Re: 1430050001 -- Peoria County Keystone Steel & Wire ILD000714881 Subpart F

Pursuant to the July 2, 1993 Consent Order (No. 93 CH 000103), Section VI; Item 28.A, Keystone was to submit a proposal for a Groundwater Management Zone which met the requirements of 35 IAC 620.250.

The Agency has reviewed the July 16, 1993 Proposed Ground Water Management Zone document, received by the Agency July 20, 1993. Based on the data and information provided in the proposal, the Agency hereby establishes a Groundwater Management Zone for Keystone Steel & Wire as described in the July 16, 1993 proposal and further described herein:

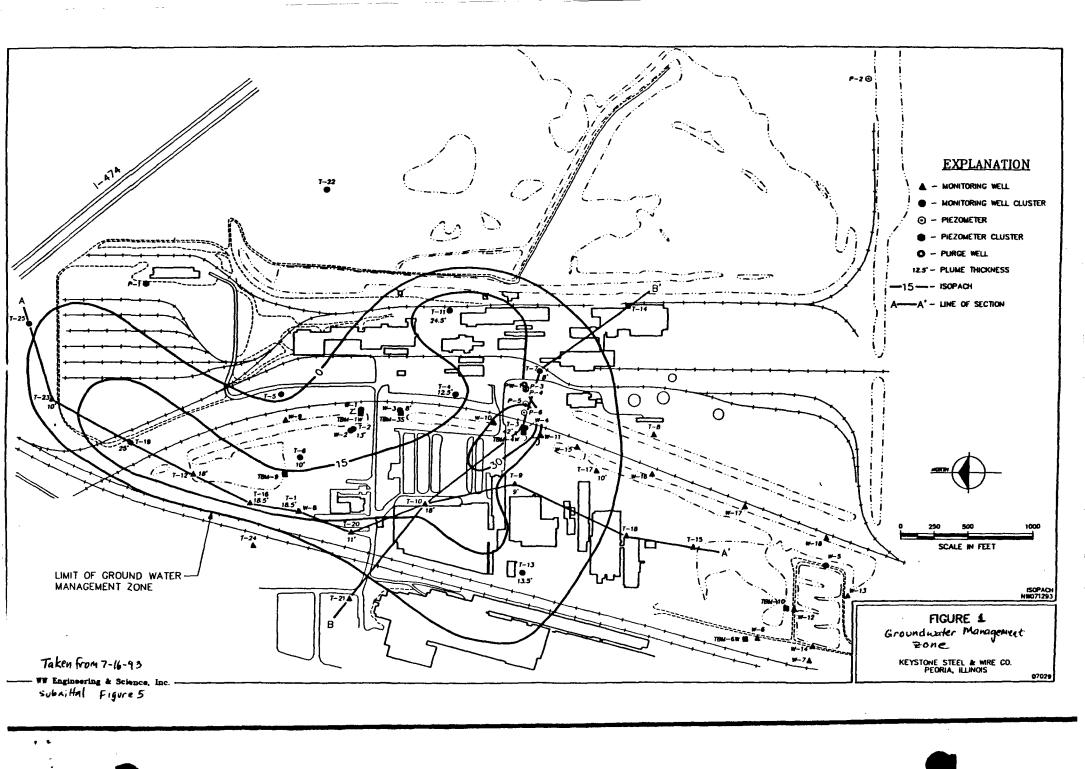
- a. groundwater monitoring wells W-1D, W-2, W-3D, W-4D, T-1, T-2A, T-3, T-4A, T-4B, T-6A, T-6B, T-7B, T-9, T-10, T-11B, T-11C, T13B, T-16, T-17, T-19C, T-20 and T-23 (as illustrated in Figure 1); and
